Nuttall Consulting

Report – Capital Expenditure Victorian Electricity Distribution Revenue Review

A report to the AER

4 June 2010

Figure 14 Calibrated repex model forecast – DNSP percentage increase

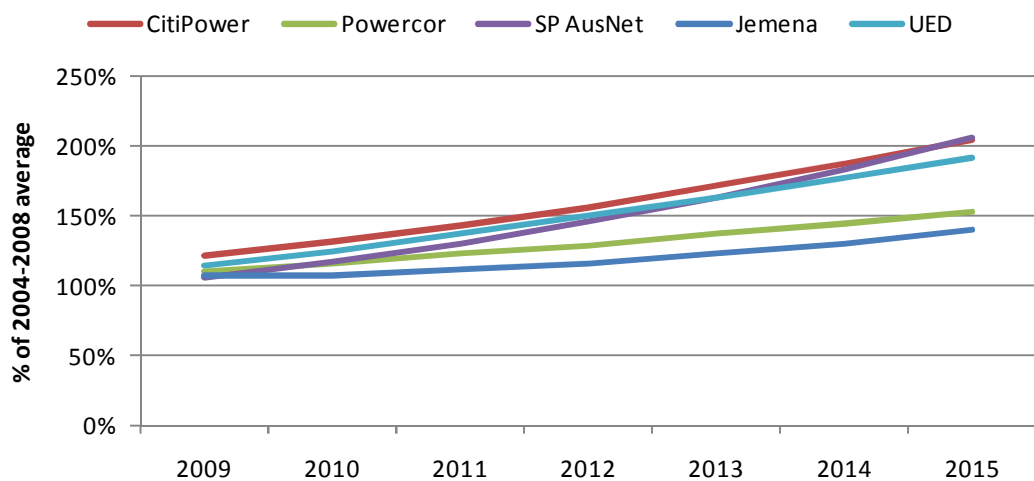
Figure 14 shows the relative scale of the increase forecast by the model for each DNSP. This figure shows a comparative plot of each DNSP repex forecast as a percentage of its average RQM expenditure over the previous 5-year period (2004-2008).

Figure 33 – CitiPower reinforcement capex recommendation

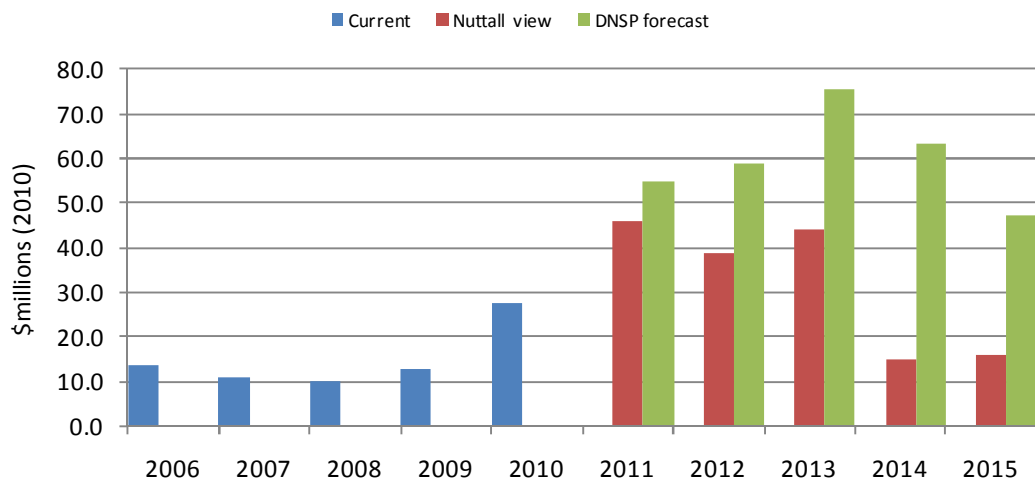
Our estimate of CitiPower's reinforcement capex is shown in Figure 33 and Table 24 below. It is important to note that this should be considered as an estimate only. The AER may need to make further adjustments to allow for its findings on the other matters, such as overheads and labour and material escalation, which are not accurately allowed for here.

Figure 56 – Jemena reinforcement capex recommendation

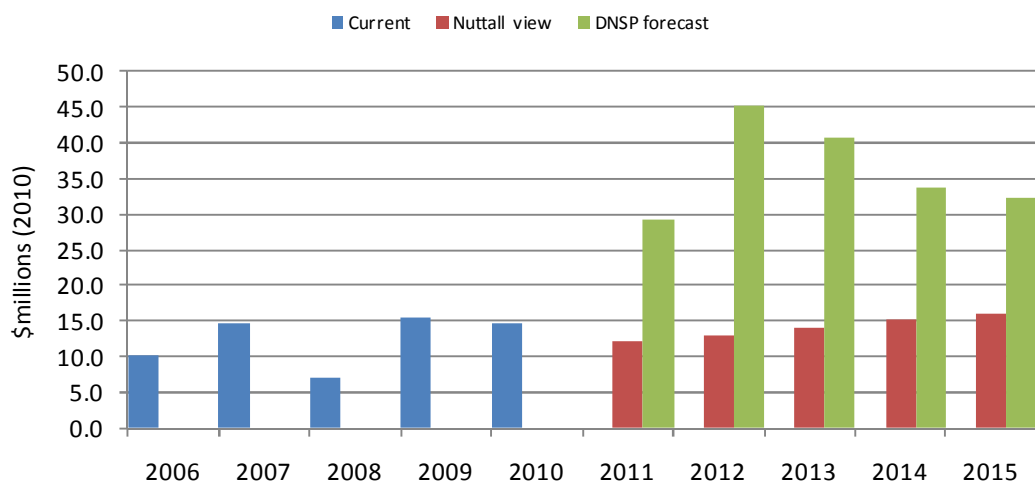
Our estimate of Jemena’s reinforcement capex is shown in Figure 33 and Table 24 below. It is important to note that this should be considered as an estimate only. The AER may need to make further adjustments to allow for its findings on the other matters, such as overheads and labour and material escalation, which are not accurately allowed for here.

Figure 58 - Jemena RQM expenditure profile

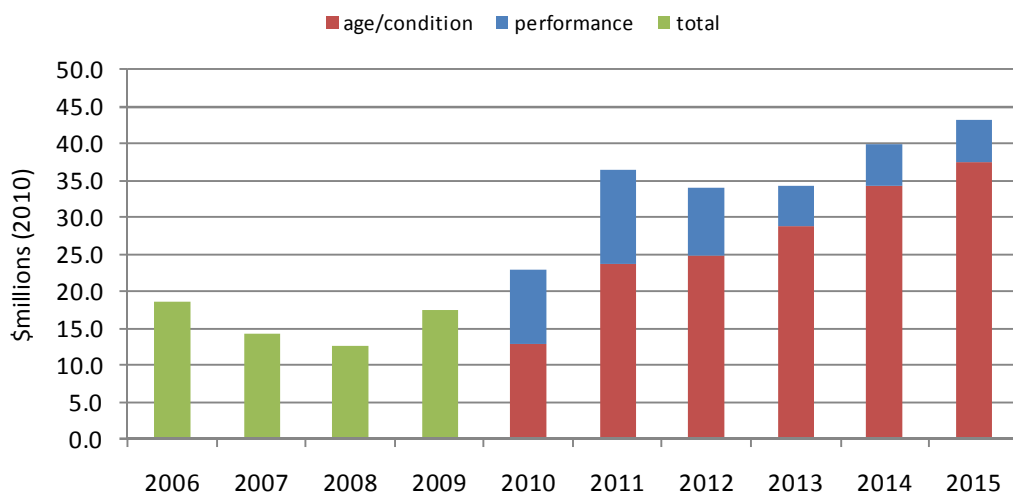
The breakdown of expenditure into the age/condition and performance drivers is shown in Figure 58. It is worth noting that this breakdown is not available prior to 2010. This figure indicates that the performance related expenditure appears to be resulting a in step increase in 2010. The underlying age/condition driven expenditure is stepping up in 2011, with a significant annual increase from that time.

Figure 60 - Expenditure profile for pole top structure replacements

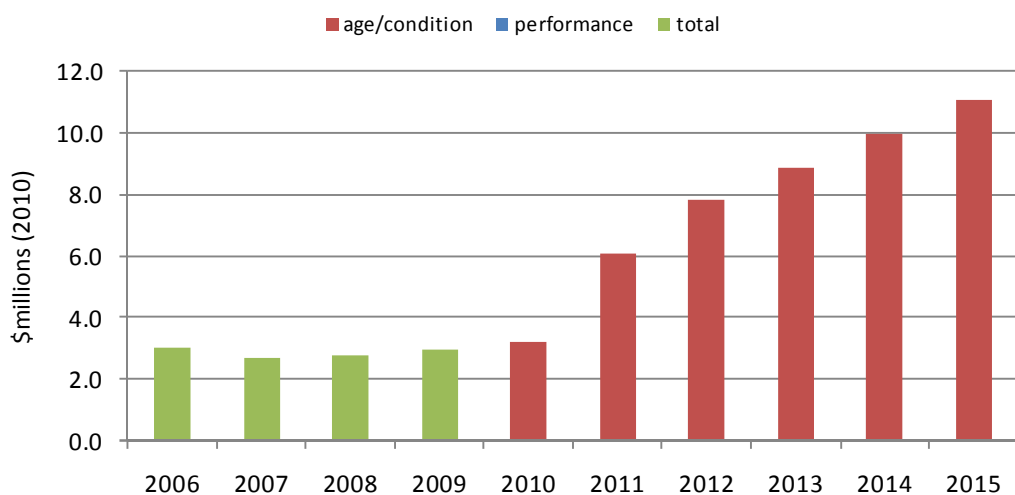
Table 48 and Figure 60 provide an overview of the expenditure in this category. This analysis indicates that this activity code represents 24% of the total RQM expenditure in the next period, with expenditure forecast to step up significantly in 2011 and then increase at a fairly significant rate well in excess of the historical trend.

Figure 61 - Expenditure profile for the zone substation plant replacement

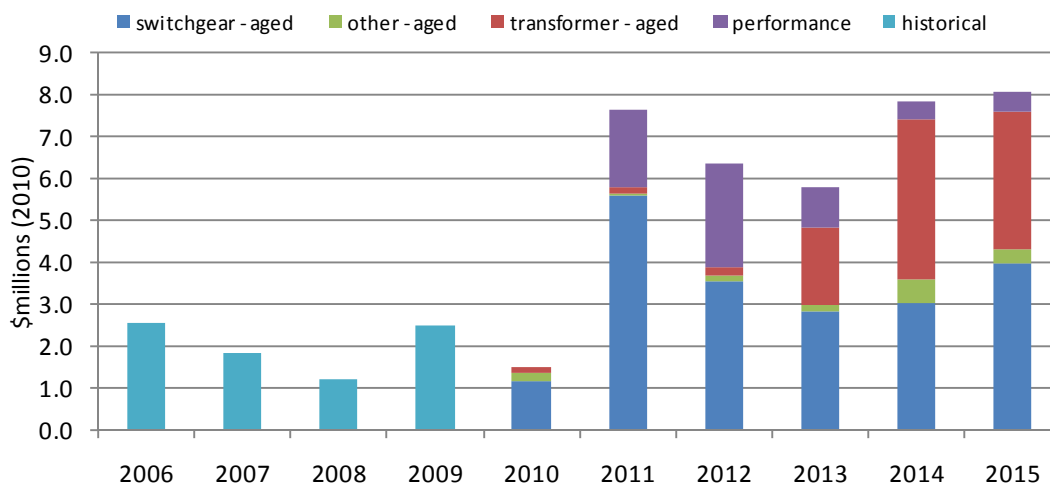
Table 49 and Figure 61 provide an overview of the expenditure in this category. Figure 61 also indicates the proportion of expenditure on the transformer and CB replacements and performance enhancements. The performance enhancements mainly include the upgrading of a transformer in 2012.

Figure 63 - Expenditure profile for conductor replacement

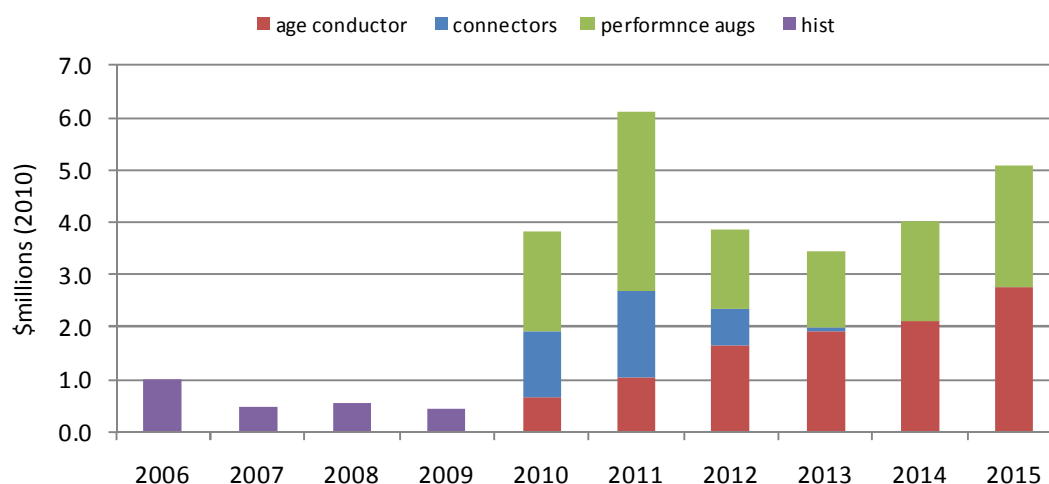
Table 51 and Figure 63 provide an overview of the expenditure in this category. Figure 63 also shows the expenditure breakdown into the three groups identified above. This analysis indicates that this activity code represents 12% of the total RQM expenditure in the next period, with expenditure anticipated to significantly increase from historical levels in 2010.

Figure 83 - Expenditure profile for the zone substation secondary system replacements

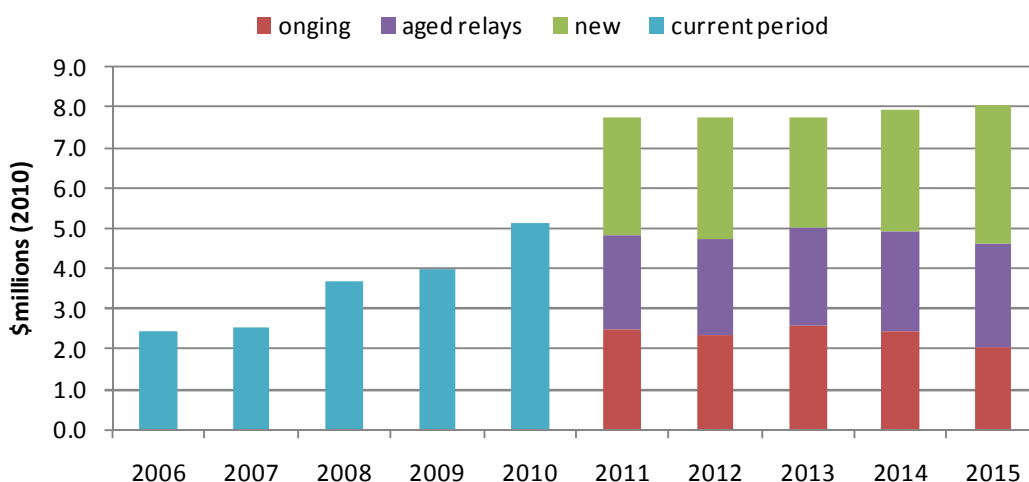
Table 69 and Figure 83 provide an overview of the expenditure in this category. Figure 83 also indicates the proportion of expenditure on the aged relays, other ongoing programs, and the new programs. This analysis indicates that this activity code represents 8% of the total RQM expenditure in the next period, with significant step increase in expenditure proposed for the commencement of the next period (2011).

Figure 88 - Expenditure profile for pole replacements

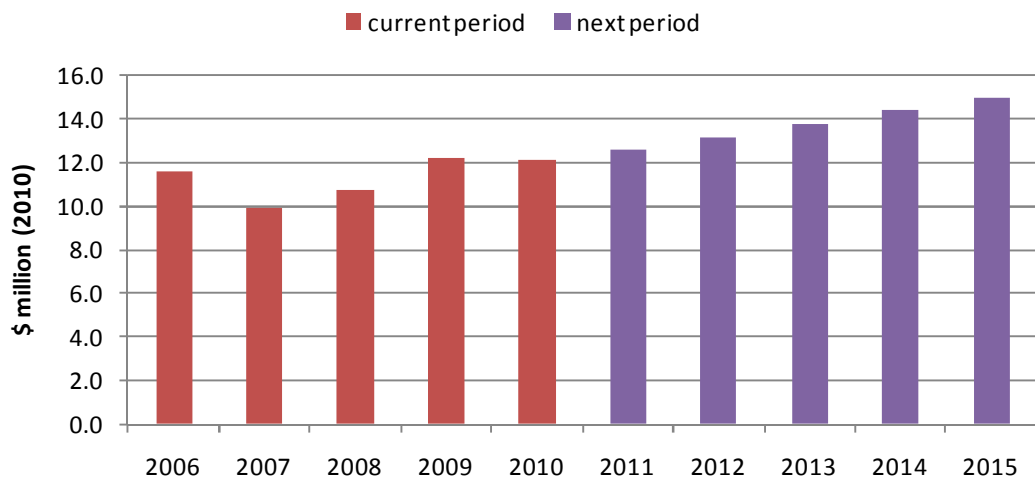
Table 74 and Figure 88 provide an overview of the expenditure in this category. This analysis indicates that this activity code represents only 15% of the total RQM expenditure in the next period, with forecast expenditure broadly on trend with historical levels.

Figure 104 - SP AusNet activity code proportion of increase

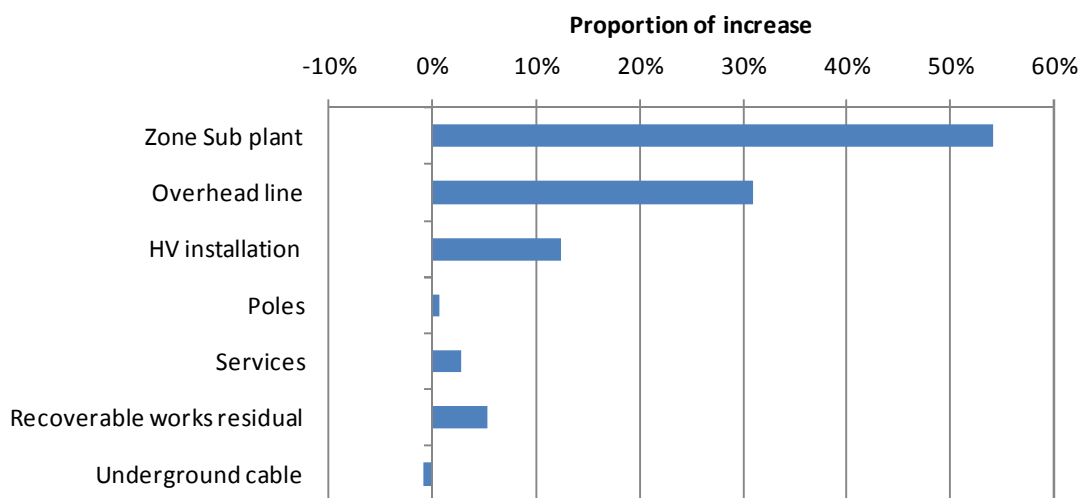
The activity code breakdown of the proposed increase in expenditure for the next period (compared to the average of 2006-2008) is shown in Figure 104. This illustrates that the expenditure on substation plant (e.g. transformers, circuit breakers) is by far the most significant contributor to the proposed increase. The overhead line activity code is also showing a significant increase.

Figure 107 – SP AusNet actual cross-arm replacements

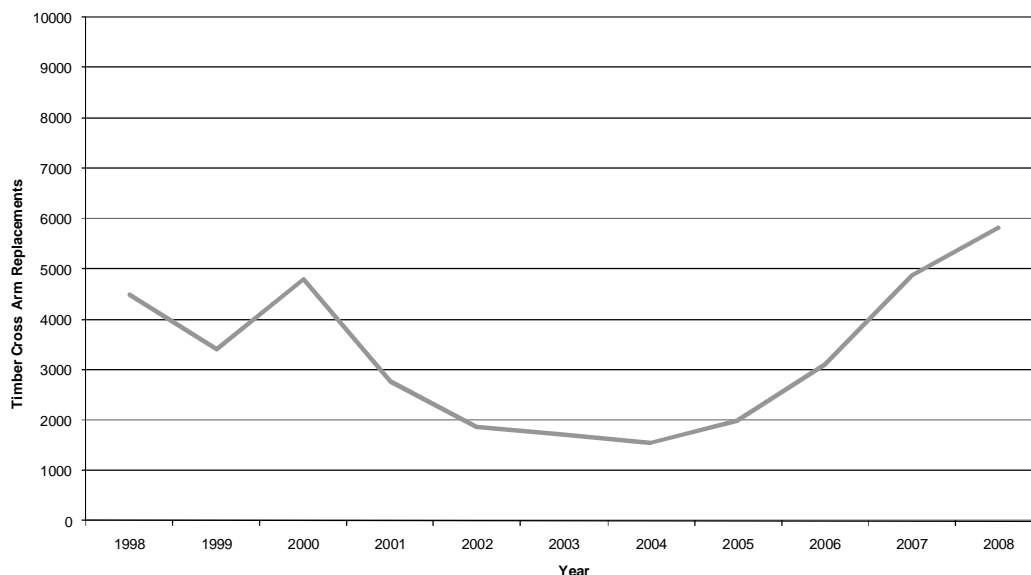
With regard to the forecast cross arm replacements, SP AusNet appears to be forecasting a step increase in replacements over historical levels. The average historical level (2006-2008) being 4800 per annum, whereas the forecast is 6551 per annum. This appears to be based upon the forecast rate being similar to the estimated rate for 2009 (see Figure 107).
